**IN THE MATTER OF:** An application for subdivision consent, pursuant to section 11 of the Resource Management Act 1991 (**RMA or the Act**) for a 55-lot subdivision (48 rural residential allotments)

**IN THE MATTER OF:** A hearing by Central Hawke's Bay District Council

**SUPPLEMENTARY STATEMENT FROM REBECCA RYDER – LANDSCAPE**

Dated 13 July 2023

**Figure 1** – GIS Spatial analysis of valley floor area.

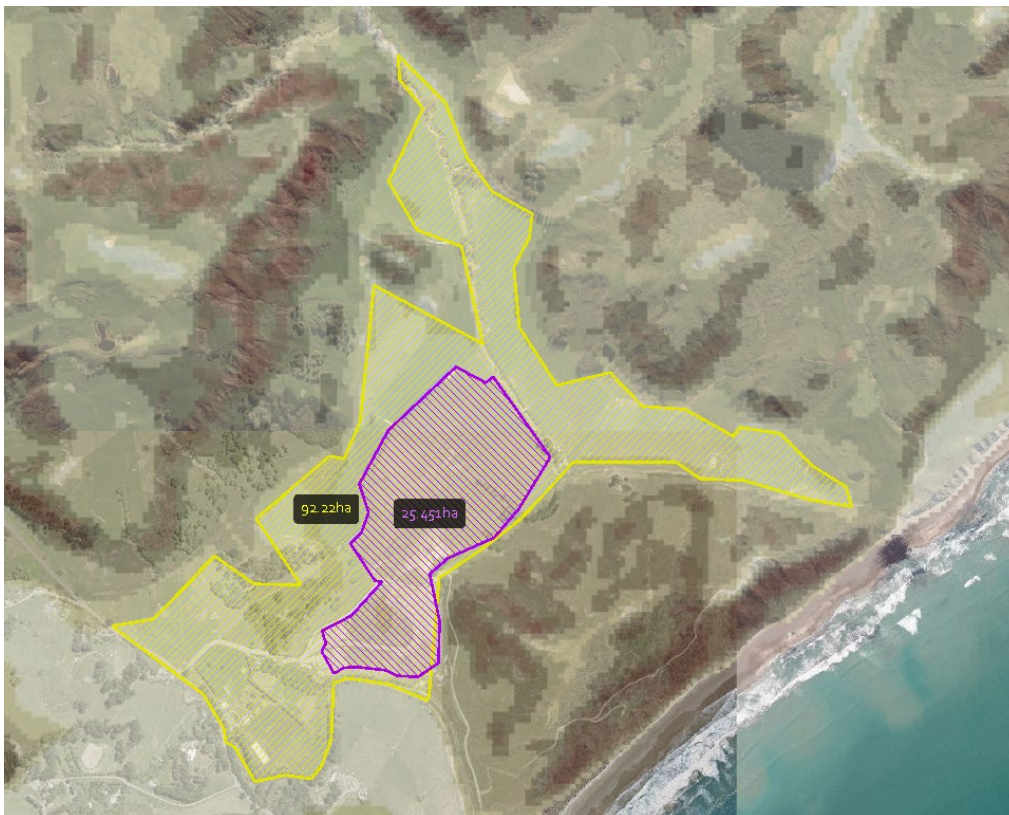
- 2.3. My concern raised around there is substantial reliance on the hillsides and localised context of surrounding rural landform creates a proposal that is small scale in this context (Refer Paragraph 42a). More specifically I consider the assessment has not considered the scale of occupation of the valley floor itself and the context of scale upon this element of the rural landscape and the spatial relationship the proposed subdivision has with the settlement patterns. The plains area is a relatively unique feature of the landscape patterns in this steep coastal environment.

- 2.4. To assist in understanding the spatial occupation of the rural landscape assessed at a local context, Figure 1 below provides a spatial understanding of the valley floor. This component of this landscape is a unique component in this coastal landscape, and this shows that the proposed subdivision, coupled with the existing subdivision occupies 27% of the valley floor component (north of the Pourerere Stream) and is sited in the widest area of the valley floor removing any dominance the rural pastoral land use has within the remaining rural landscape. In my opinion this not small scale in the context of this localised rural landscape.
